Hillingdon

Outline Fire Strategy – Rev E

OF-OFS-3671-01-E

Appendix A – Drawing Comments

1 Building 4 - Ground Floor Plan
1 : 200

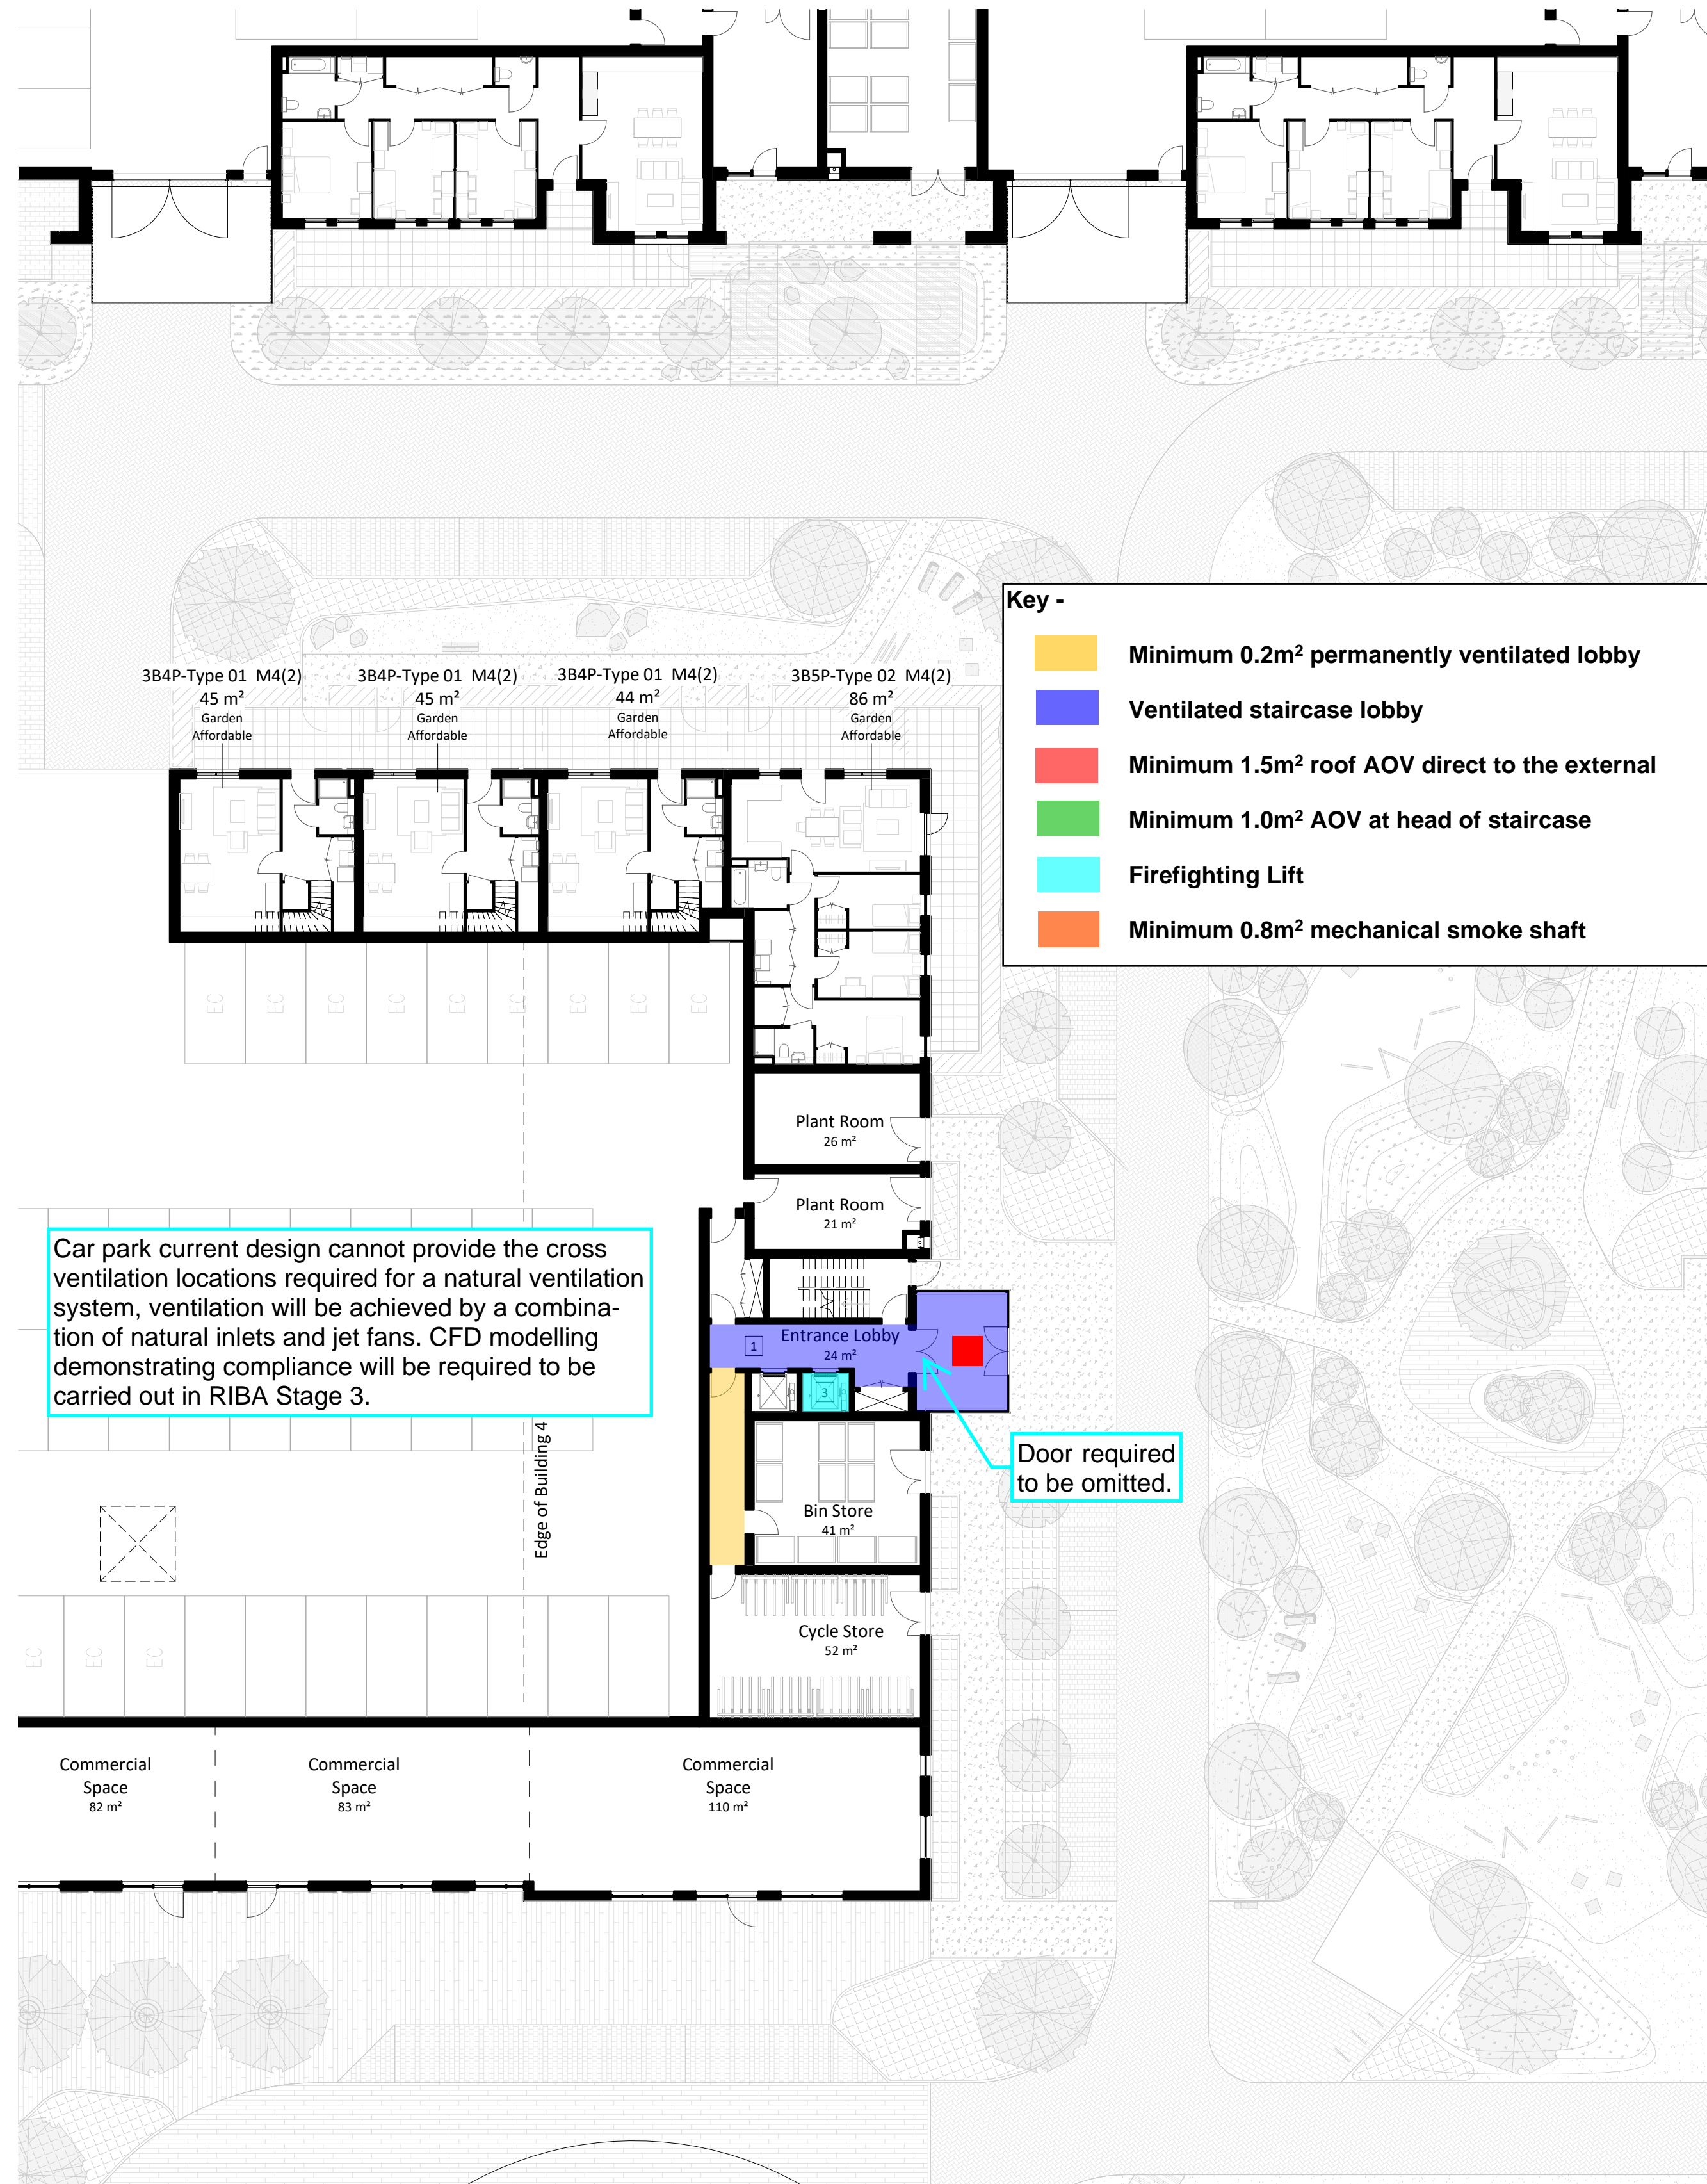
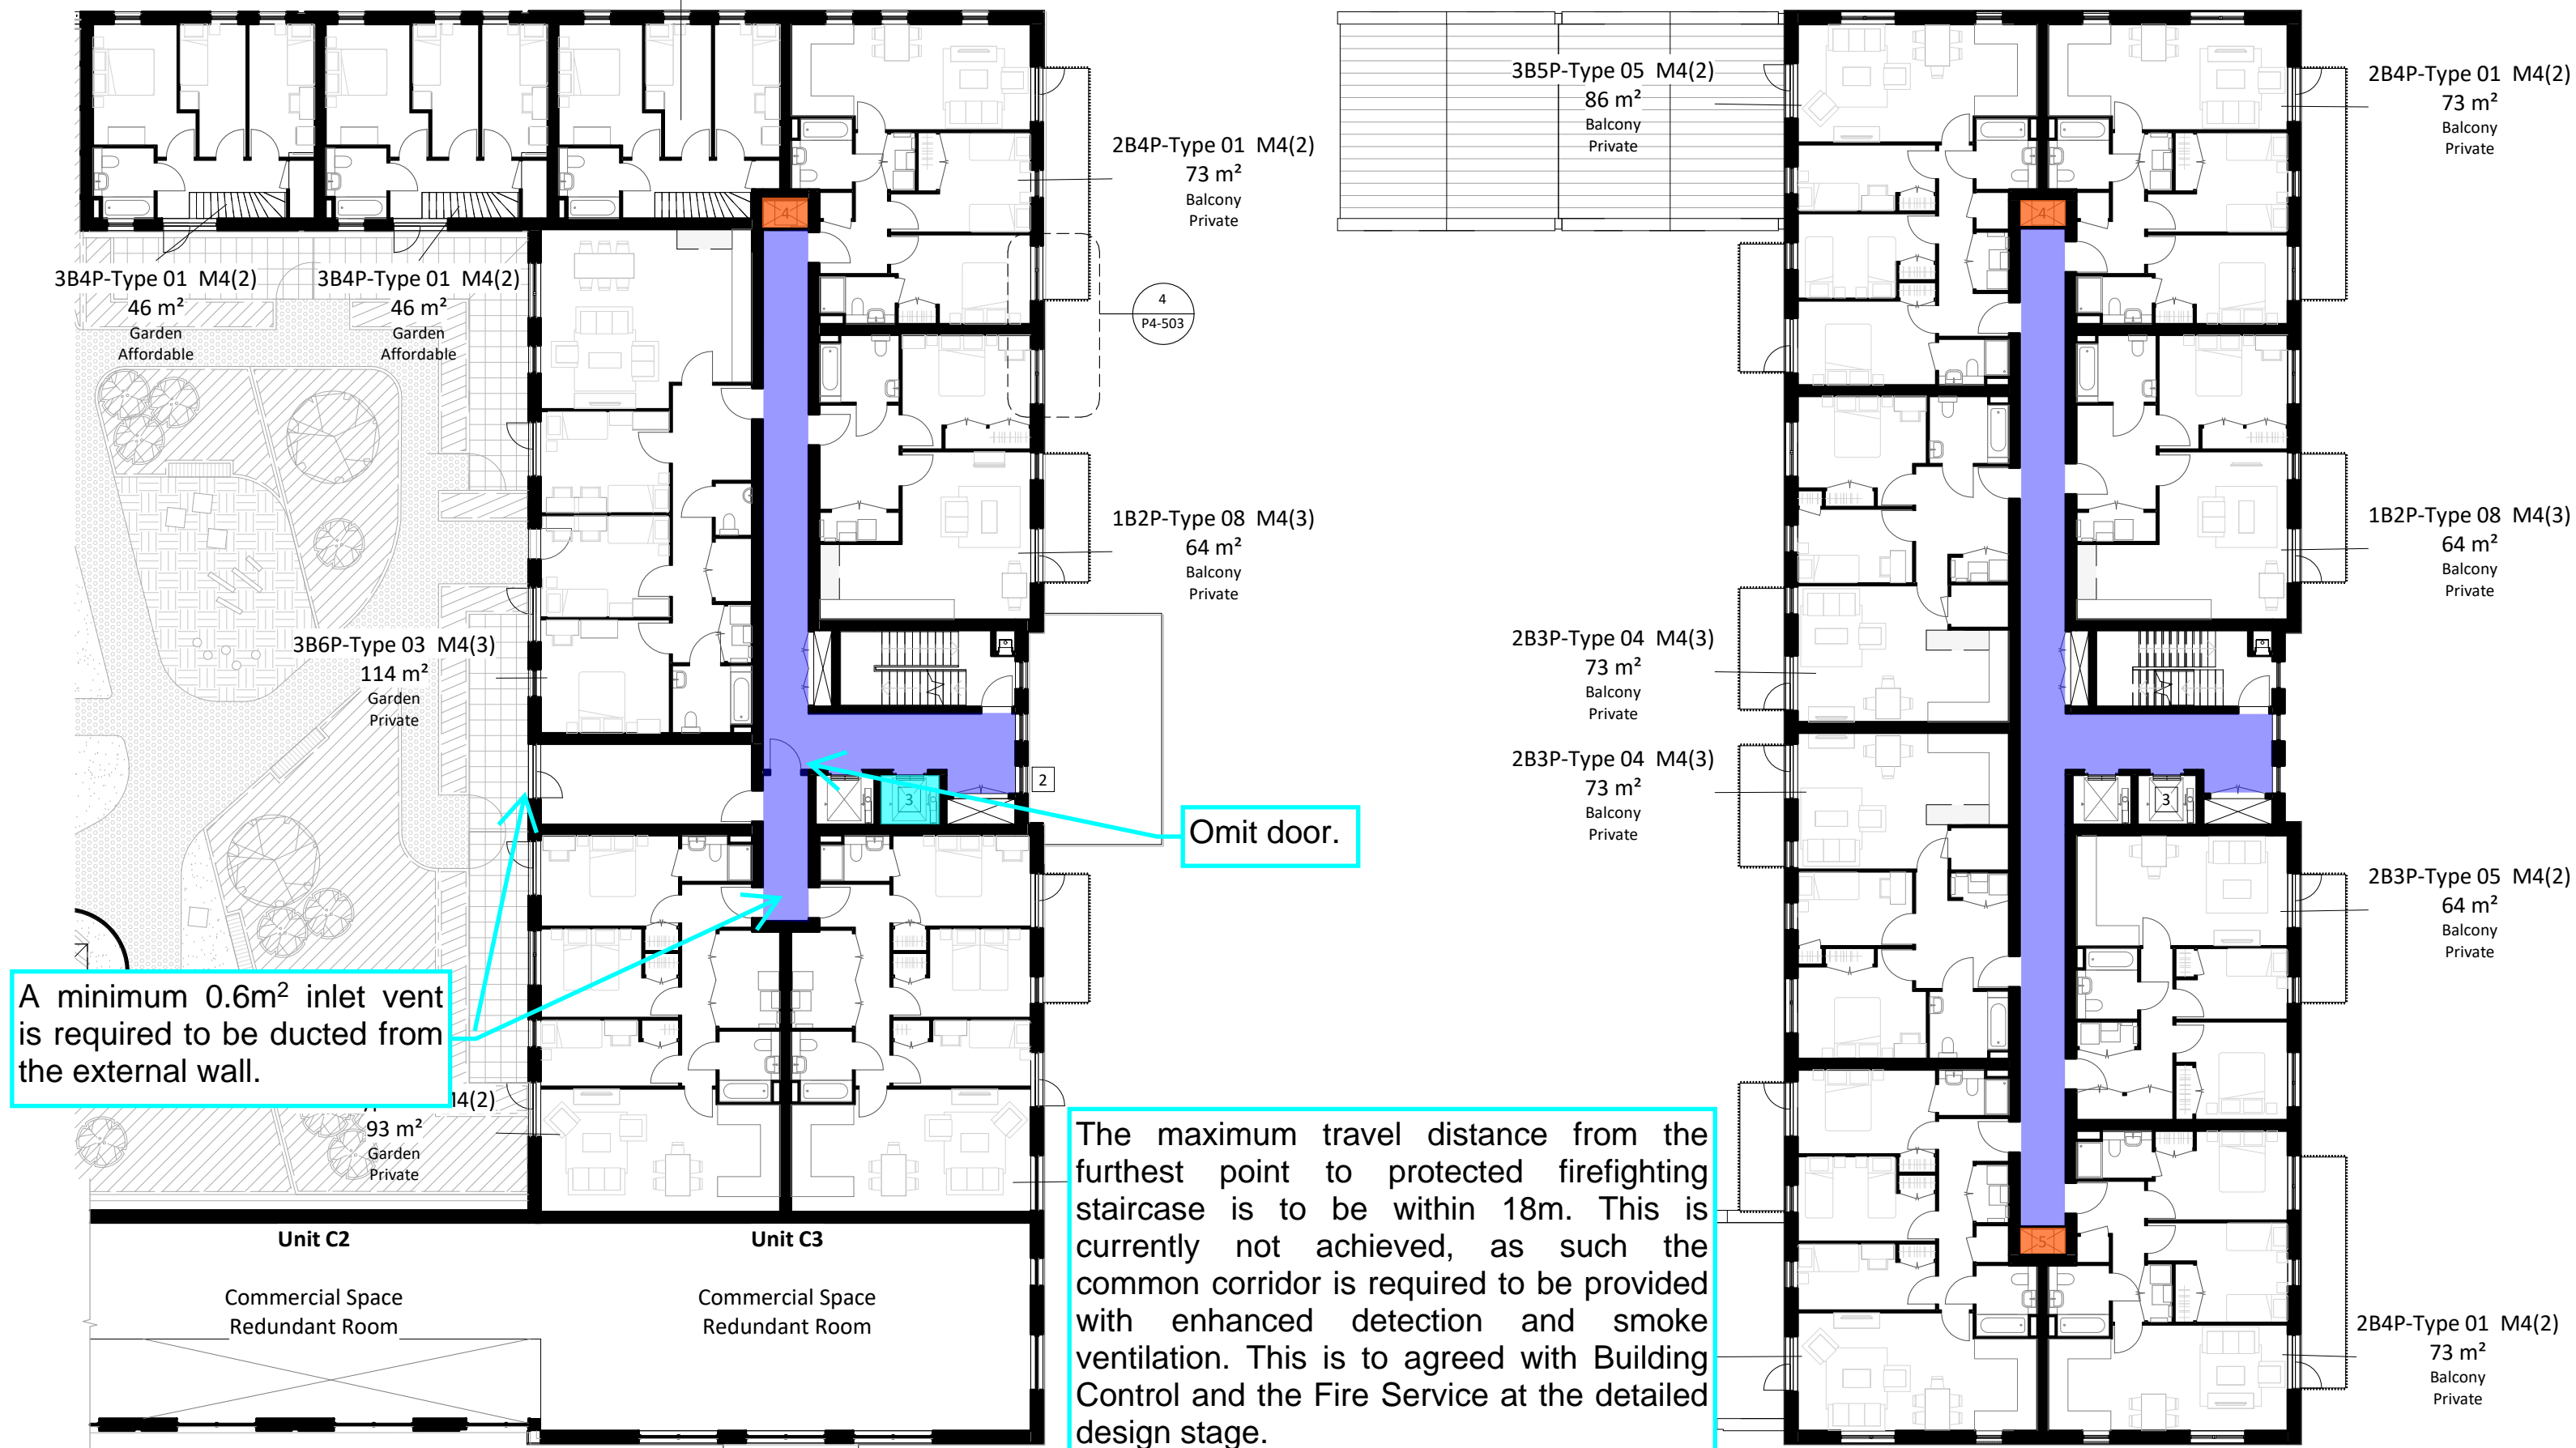
The cross-corridor doors and the lobby AOV's direct to the external are to be omitted, allowing for 2x 0.8m² mechanical smoke shafts are to be provided at the remote ends of the corridors (one at each end). CFD modelling would be required to justify this deviation. However, considering that the travel distance isn't excessive and that the apartments are not impeding the vertical escape route, it is considered that this proposed solution has limited design risk.

To be noted, the government have stated from May 2020, all new building's over 11m in height are required to be provided with sprinklers, see Section 9.
